**RE: Tucson South Resource, M-2004-044, Amendment Number 1 (AM01)
Adequacy Review No. 2**

Enclosure: *Memorandum, Adequacy Review of Exhibit 6.5 – Geotechnical Stability Adequacy Response
Aggregate Industries; Tucson South Resource; File No. M-2004-044; AM0, Dated July 25, 2019*

**Re: Adequacy Review of Exhibit 6.5 – Geotechnical Stability Adequacy Response
Aggregate Industries; Tucson South Resource; File No. M-2004-044; AM-01**

Project Tucson South AM
J-1 - Static
File: G:\My Drive\1 - My Projects\Google\8 Galena - Stability Analysis Models\Tucson South\Tucson Figure J -1 Static.gmf

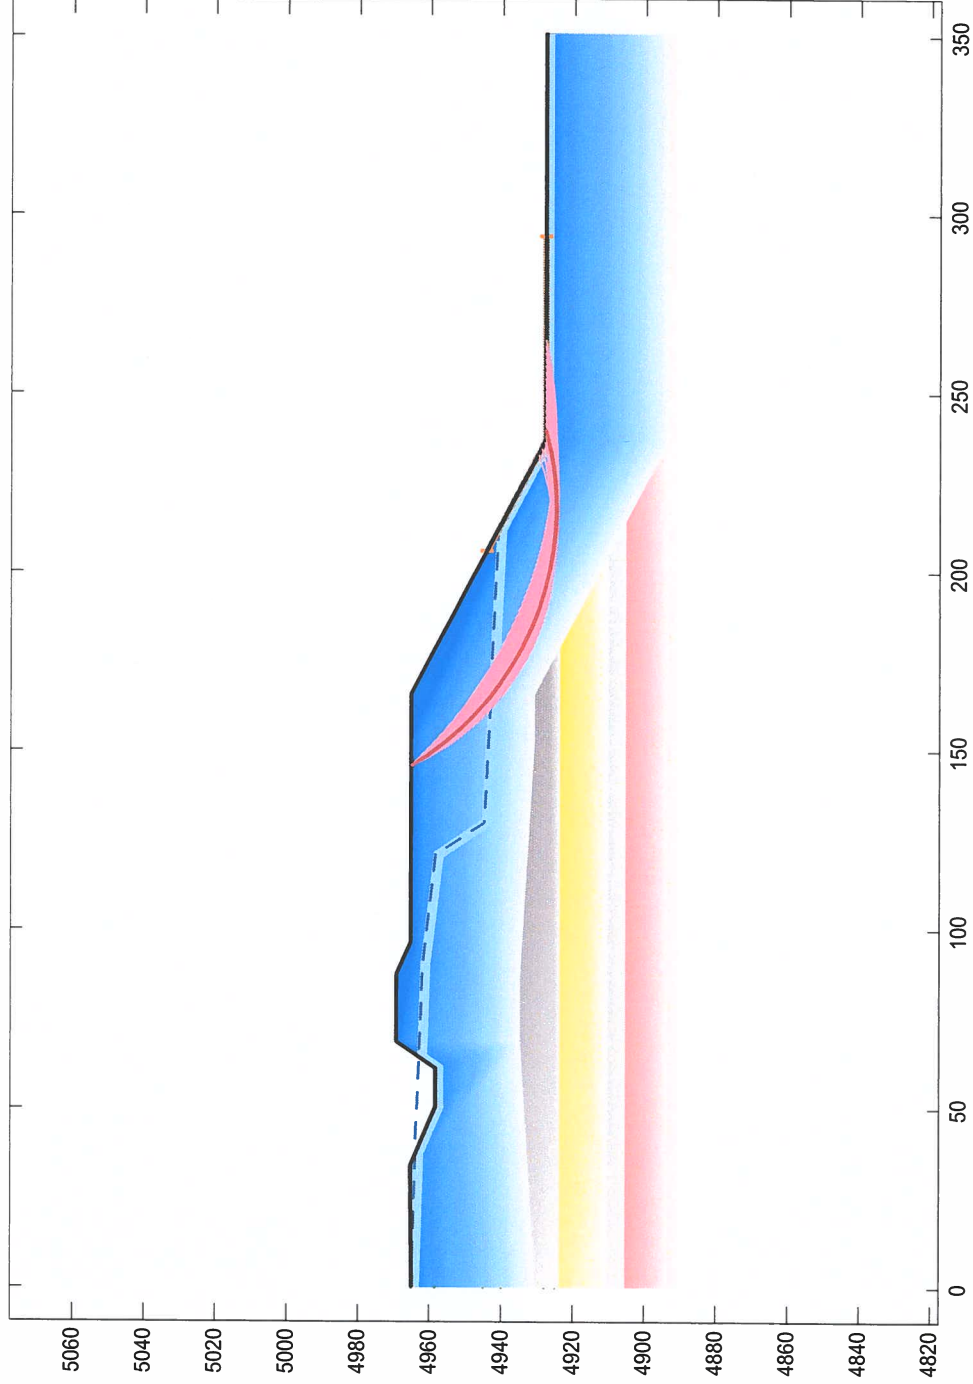
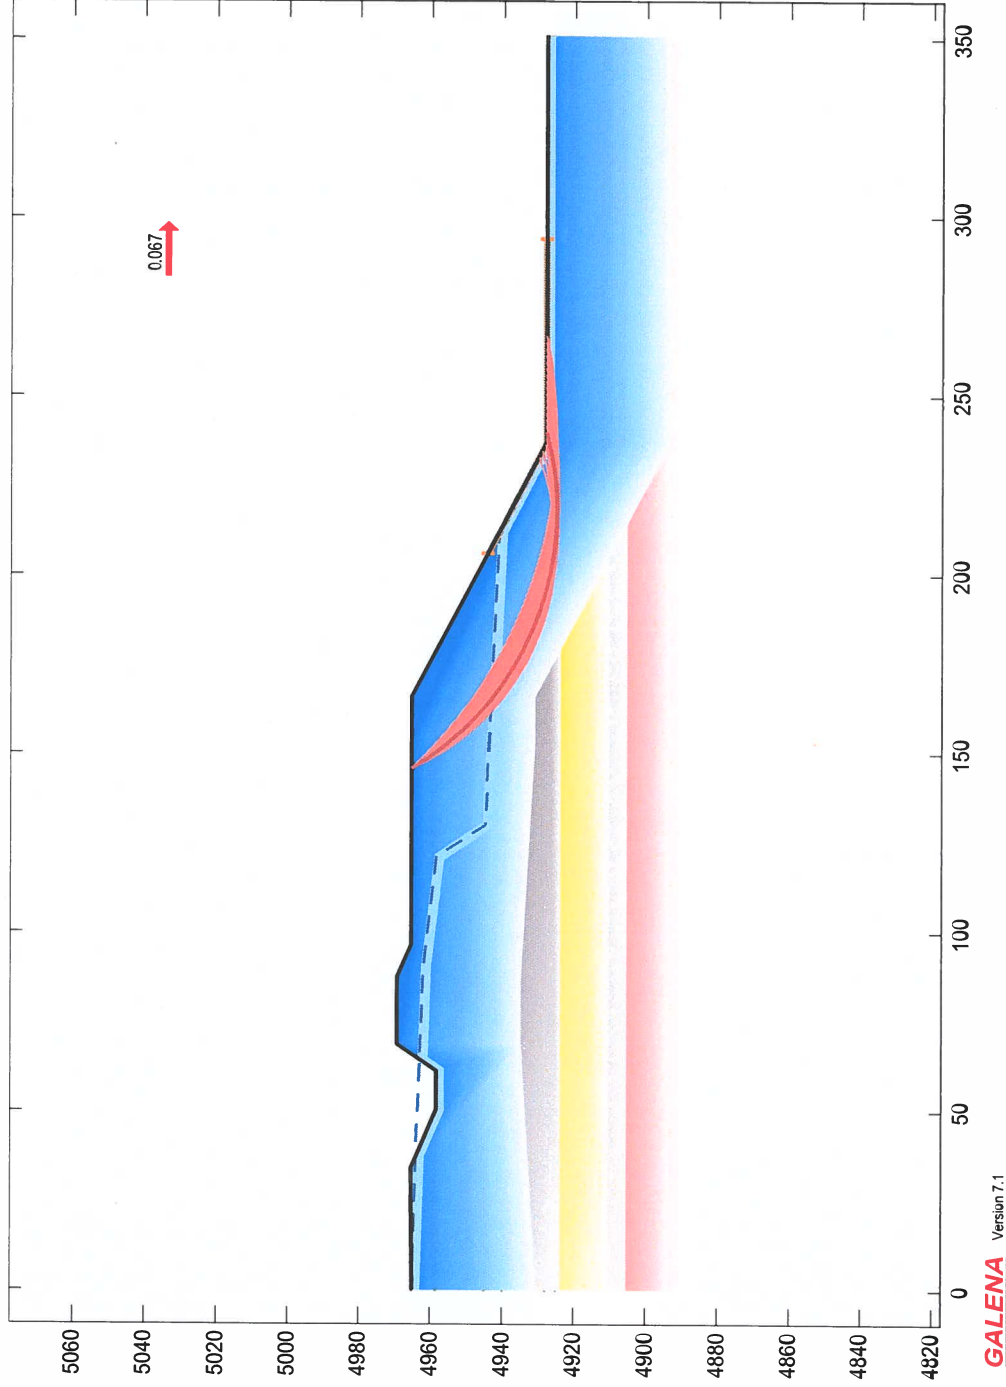
6. The Applicant modeled the Figure J analysis which produced a minimum FOS located 44 feet from the edge of the Brighton Return Ditch. The Exhibit C-3 Map indicates the Applicant modeled a 77 feet offset. Please explain this discrepancy and revise the Figure J models and/or the Exhibit C-3 Map accordingly.

The Division duplicated the Figure J models with the 77 feet offset from the edge of the Brighton Return Ditch. The models produced factors of safety of 1.07 – Static and 0.89 – Pseudostatic, which do not meet the required FOS. Please review the Applicant's and Division's models and reevaluate the proposed offset distance from the Brighton Return Ditch to conform to the FOS requirement of the MLRB.
